As-built Baseline Monitoring Report

**Stony Fork Restoration Site
Upper Neuse River Basin - 03020201
Monitoring Year 00
DMS Contract 6830
DMS Project Number 97085**

Date: August 7, 2019
To: Lindsay Crocker, DMS Project Manager
From: Adam Spiller, Project Manager
KCI Associates of North Carolina, PA
Subject: MY-00 Monitoring Report Comments
Stony Fork DMS #6830, Contract 006830
Neuse River Basin CU 030202018
Johnston County, North Carolina

As-Built Drawing Comments:

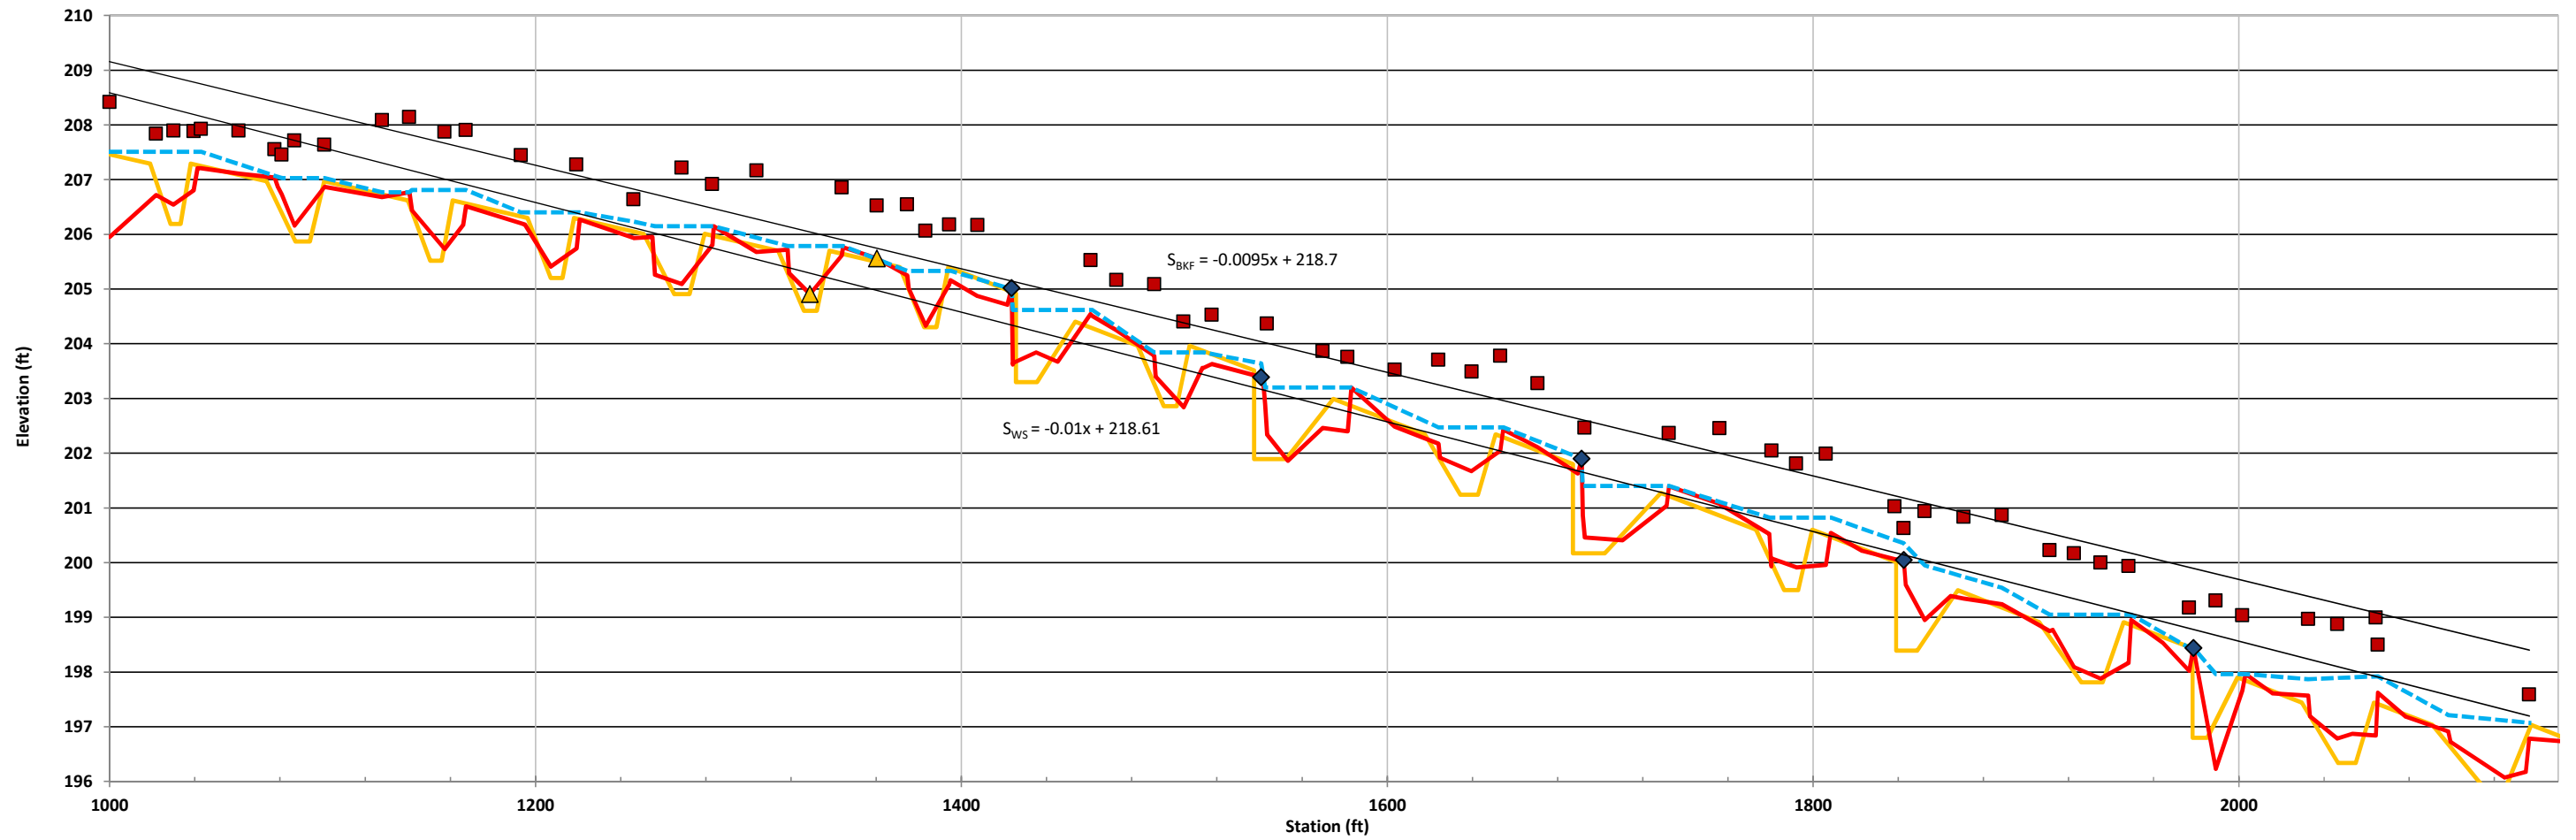
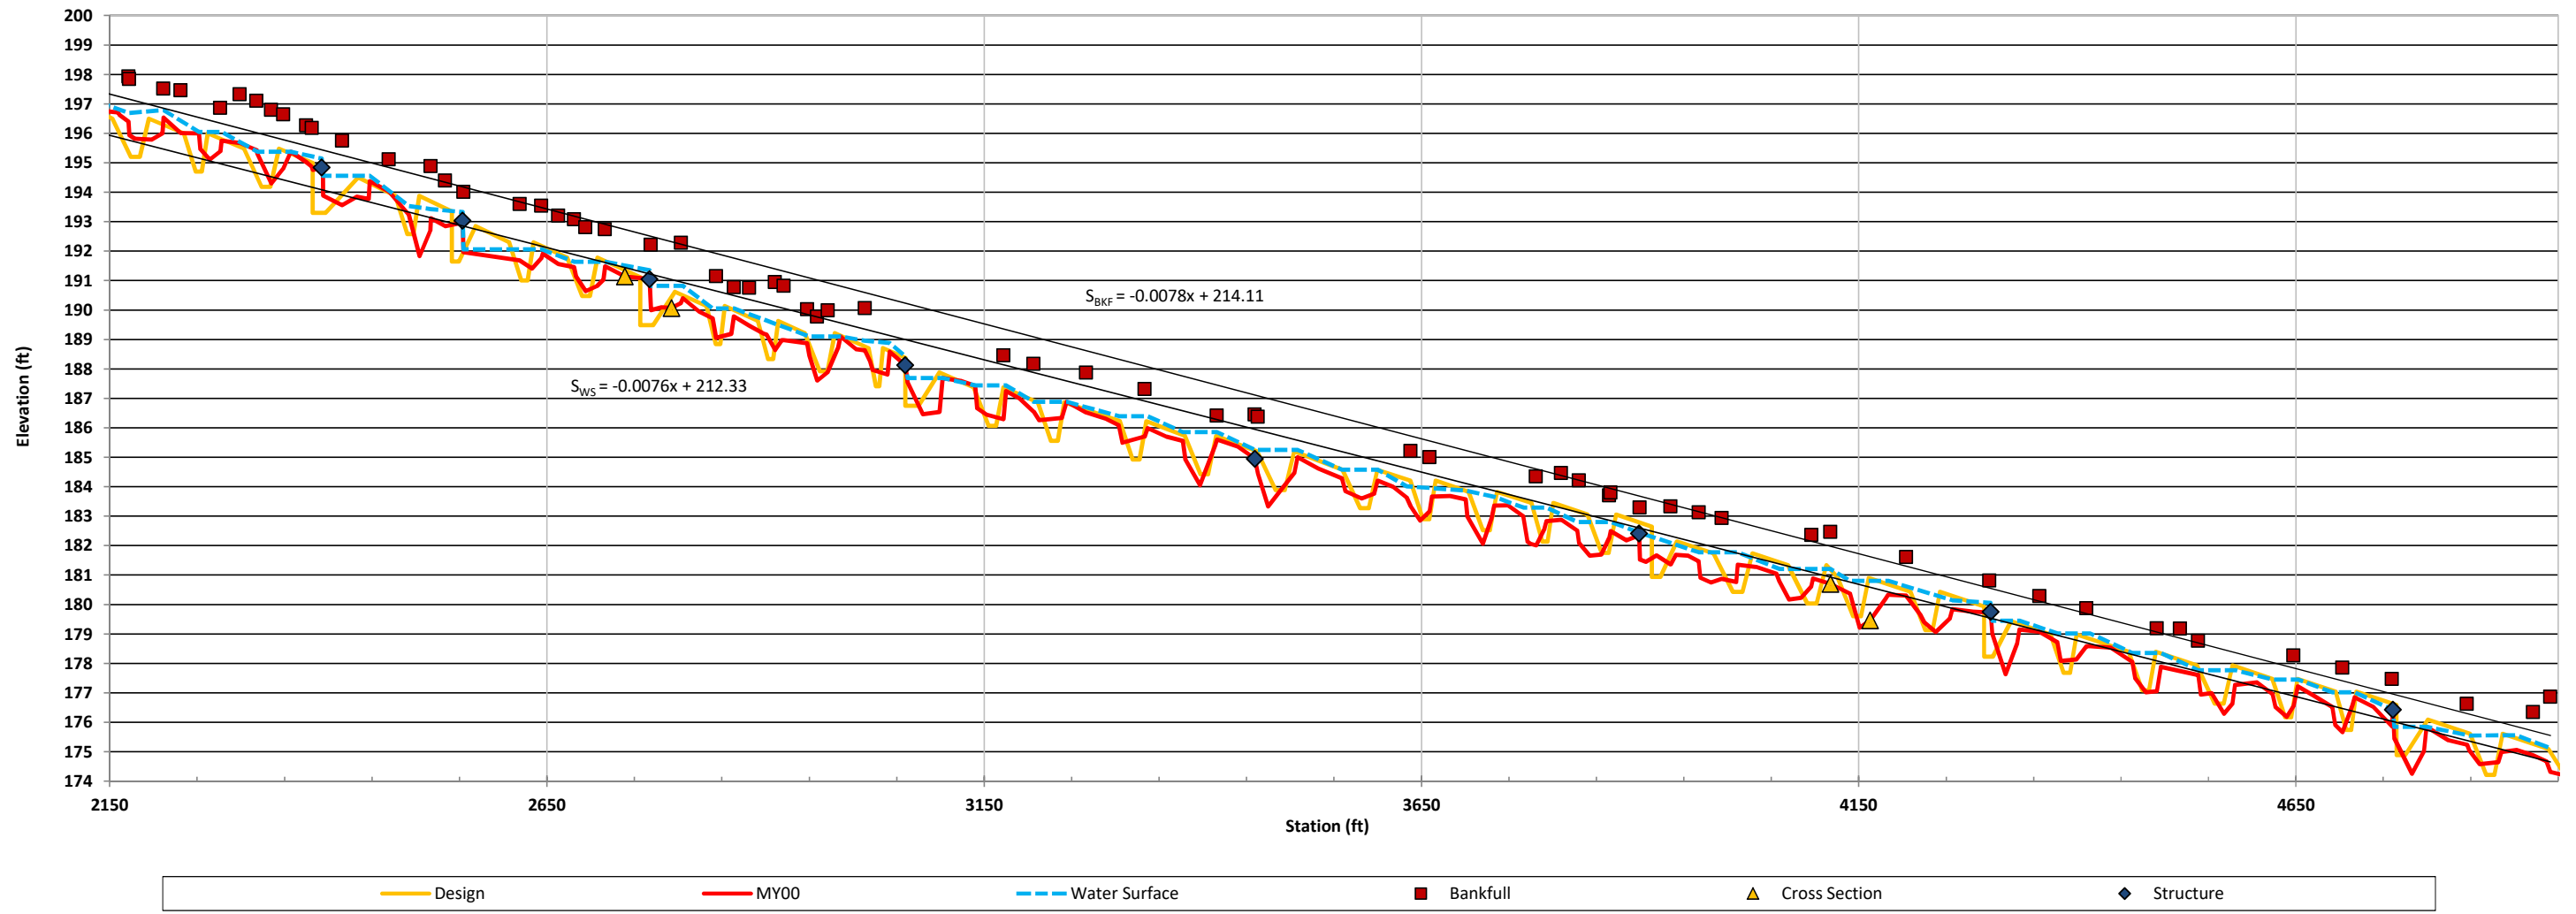
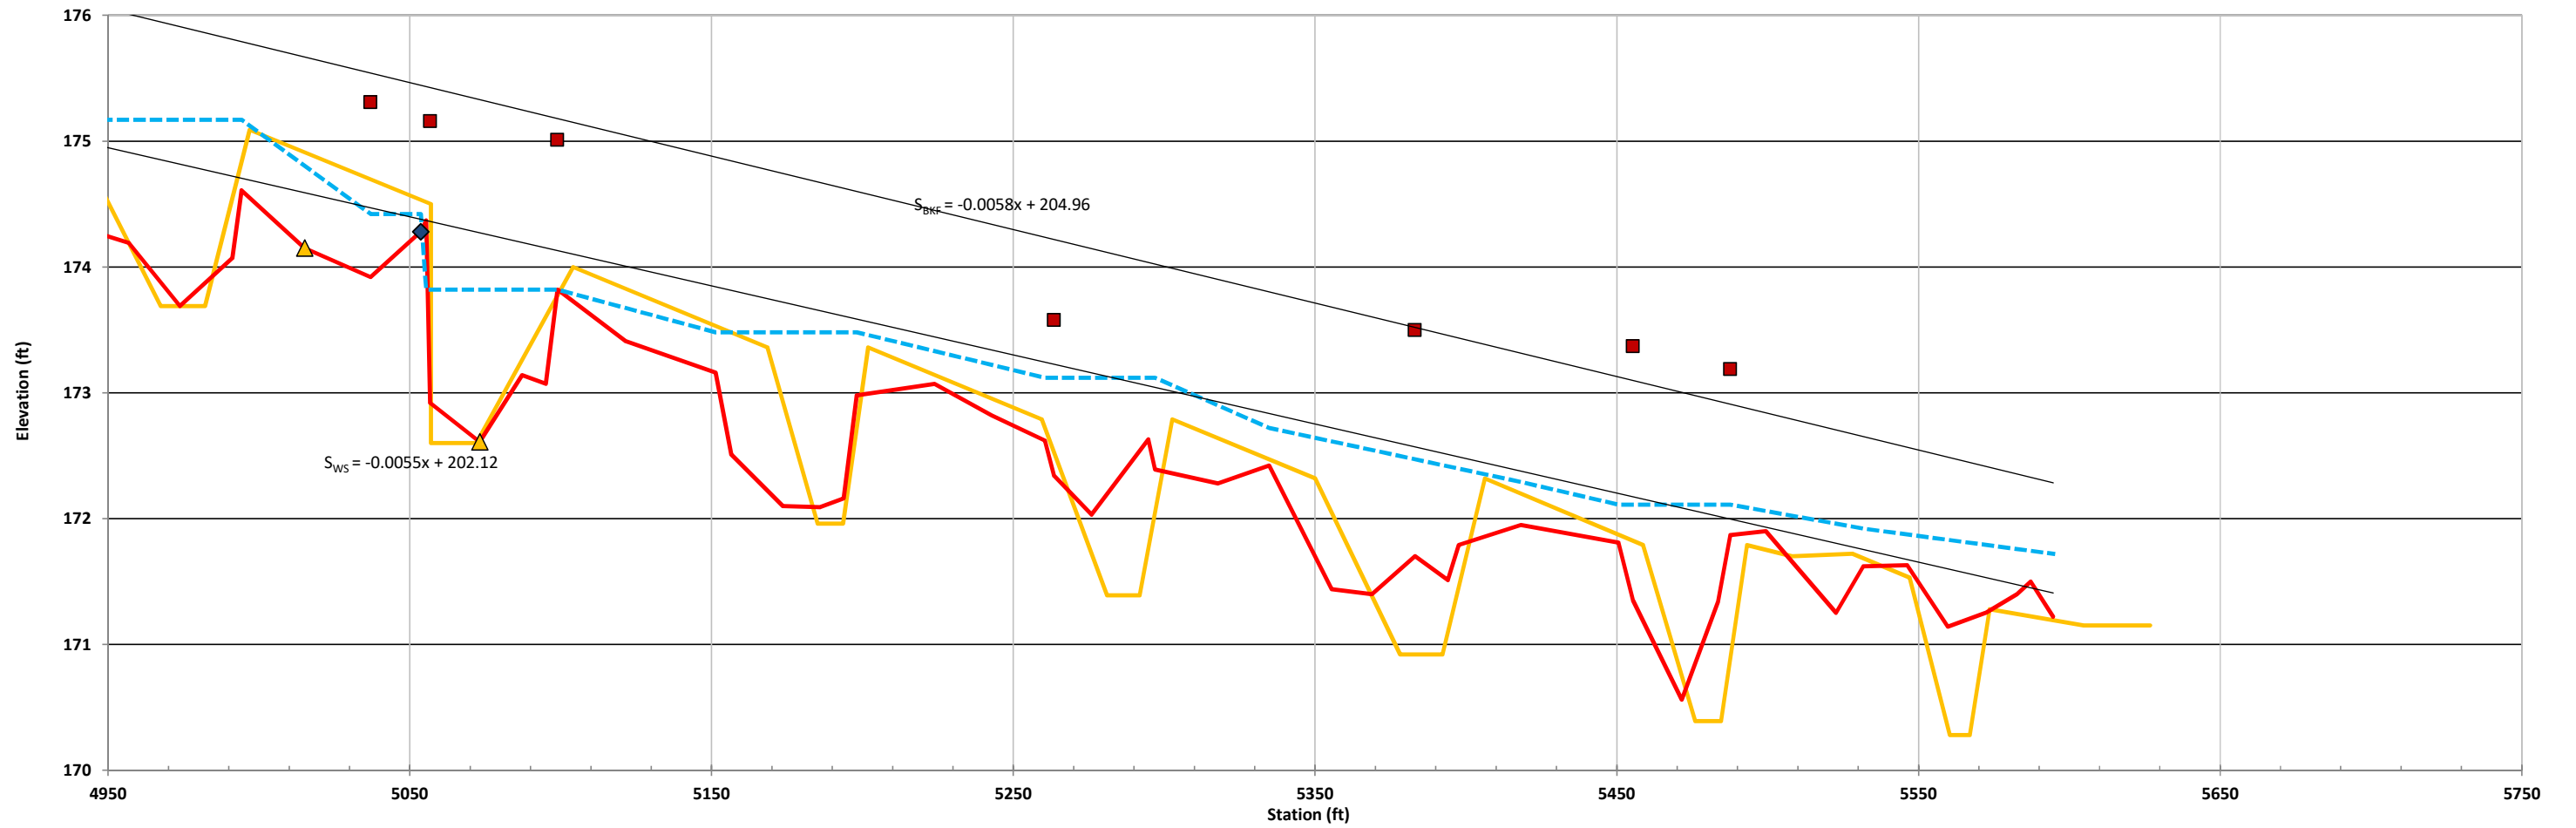
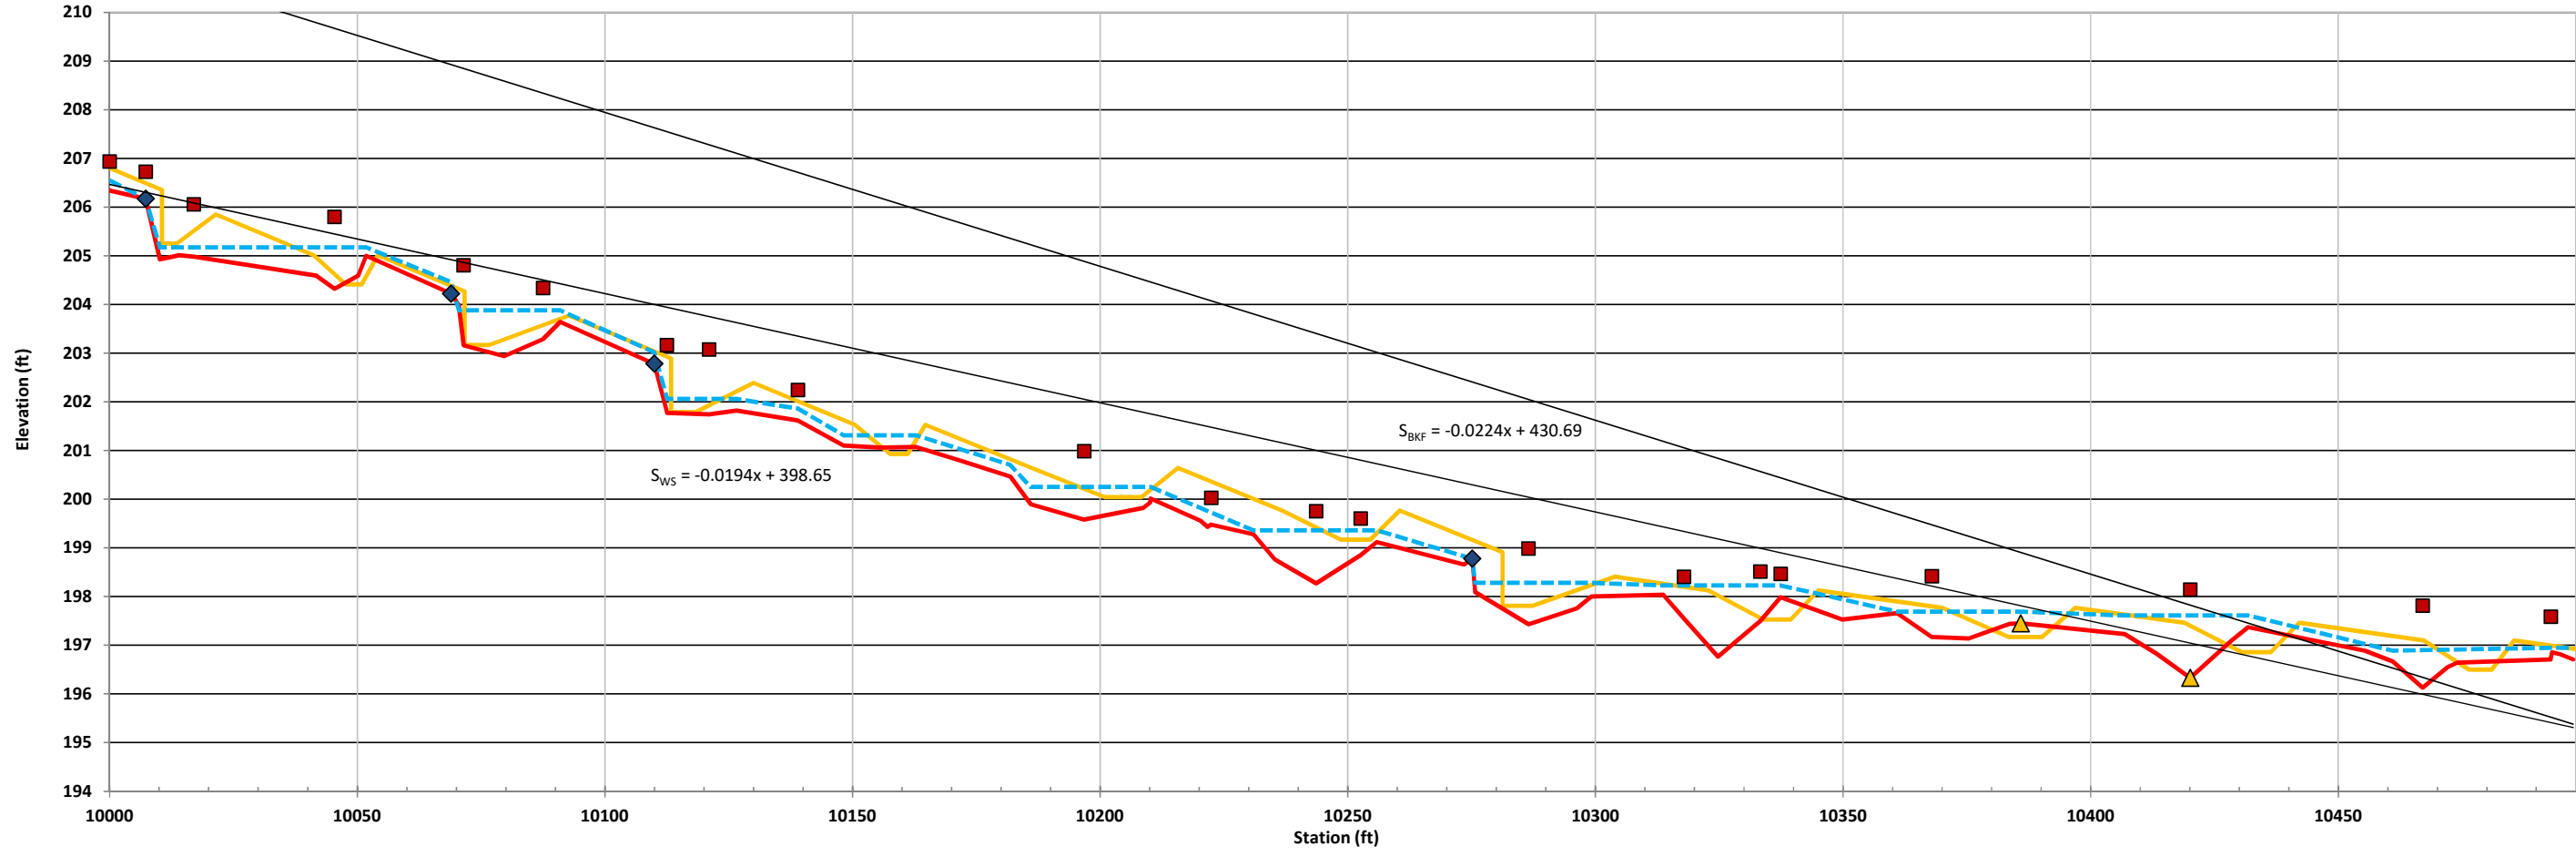
- Long-pro: can you overlay design thalweg? This appears to show in the legend on a few reaches, but it not visible.
 - *This change has been made.*
- Table 1. Please re-name the 'Restoration Footage' column to 'As-Built Restoration Footage.' Provide a column to the left of 'Restoration Footage' that shows the 'MP Restoration Footage' (DMS understands there are slight differences on SF2 and SF3). Make a footnote that project credits are based on Mitigation Plan credits. There is a lot of confusion as to what the IRT would like to use for crediting, and DMS would like to make the numbers as visually clear as possible.
